# **Structural Glitch Modifications**

This document created by the Florida Department of Community Affairs -  
850-487-1824

**Sub Code: Building**

Total Mods for Structural: 115

**FIGURE R613.5(4)**  
**SIP WALL TO WALL PLATFORM FRAME CONNECTION**

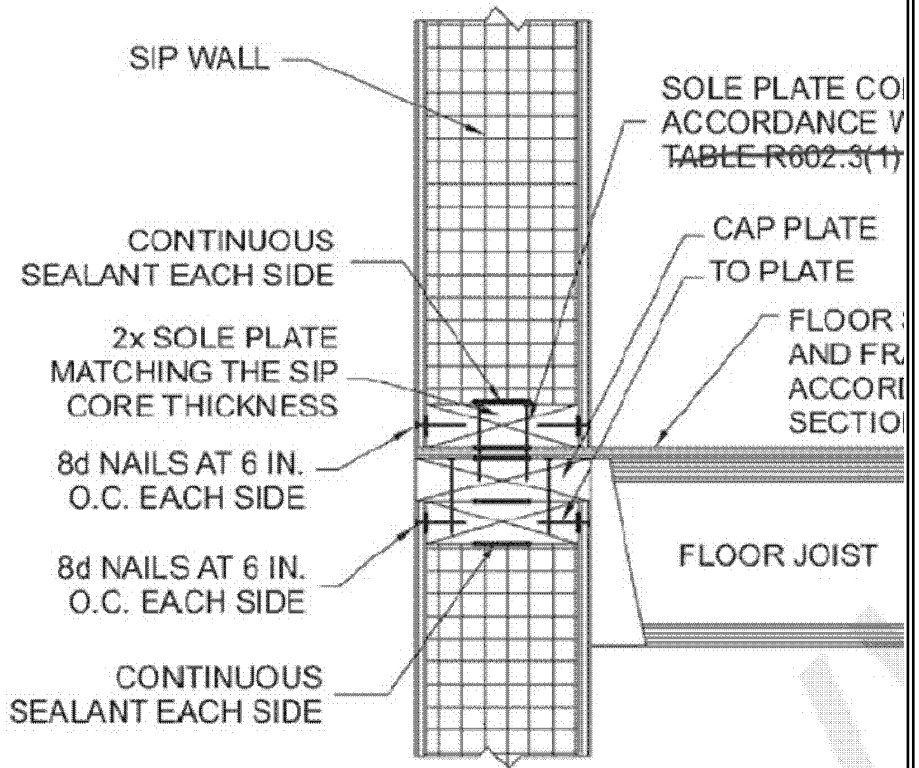
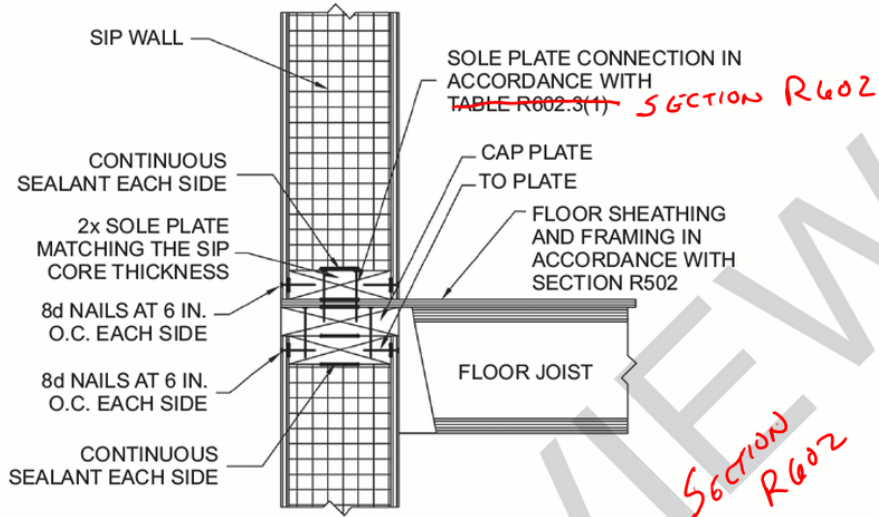
Note: Figures illustrate SIP-specific attachment requirements. Other connections shall be made in accordance with Tables R602.3(1) and (2), as appropriate.
